# UNITED STATES PATENT AND TRADEMARK OFFICE

APPLICATION NO.	FILING DATE	FIRST NAMED INVENTOR	ATTORNEY DOCKET NO.	CONFIRMATION NO.
10/026,961	12/27/2001	Young Hun Ha	8733.524.00	7359
30827	7590	10/08/2004	EXAMINER	
MCKENNA LONG & ALDRIDGE LLP			LANDAU, MATTHEW C	
1900 K STREET, NW			ART UNIT	
WASHINGTON, DC 20006			PAPER NUMBER	
			2815

**Office Action Summary**

## DETAILED ACTION

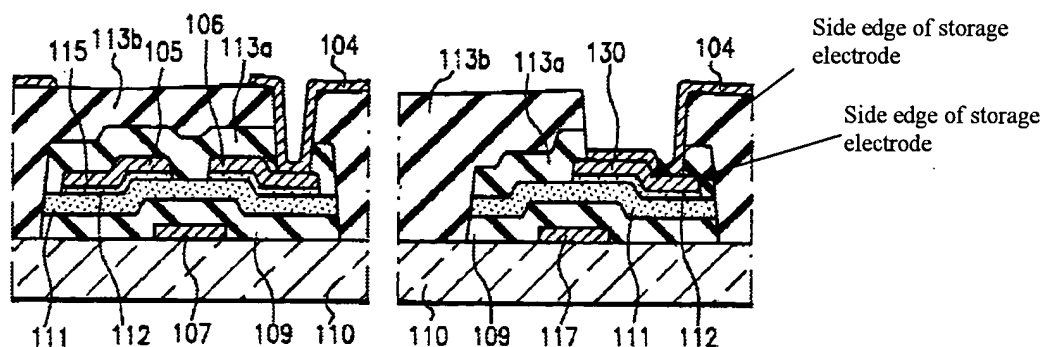
In regards to claim 1, Figures 4 and 5I of Han disclose a liquid crystal display device including a data line 115 supplied with a data signal, a gate lines 117 supplied with a scanning signal, a pixel electrode 104 for driving a liquid crystal cell, and a thin film transistor for responding to the scanning signal to switch the data signal to the pixel electrode, the device comprising: a storage electrode 130 overlapping with the gate line to form a storage capacitor; a first protective layer 113a being formed between the storage electrode and the pixel electrode at a portion of an overlapping area between the storage electrode and the pixel electrode (portion over the right side of the storage electrode, as shown in Figure 5I), wherein the storage electrode is directly connected to the pixel electrode at an end of the overlapping area (Figure 5I); and a second protective layer 113a formed between a gate insulating film 109 and the pixel electrode.

In regards to claim 2, Figure 5I of Han discloses the gate insulating film 109 on a substrate 110 in such a manner to cover the gate line; and a first semiconductor layer 111/112 between the gate insulating film and the storage electrode.

In regards to claim 6, Figures 4 and 5I of Han disclose a liquid crystal display device including a data line 115 supplied with a data signal, a gate lines 117 supplied with a scanning signal, a pixel electrode 104 for driving a liquid crystal cell, and a thin film transistor for responding to the scanning signal to switch the data signal to the pixel electrode, the device comprising: a storage electrode 130 overlapping the gate line to form a storage capacitor; and the pixel electrode covering an upper surface and side edges of the storage electrode, wherein the storage electrode is directly connected to the pixel electrode at an end of an overlapping area between the storage electrode and the pixel electrode. A marked-up version of Figure 5I is provided below for clarification.
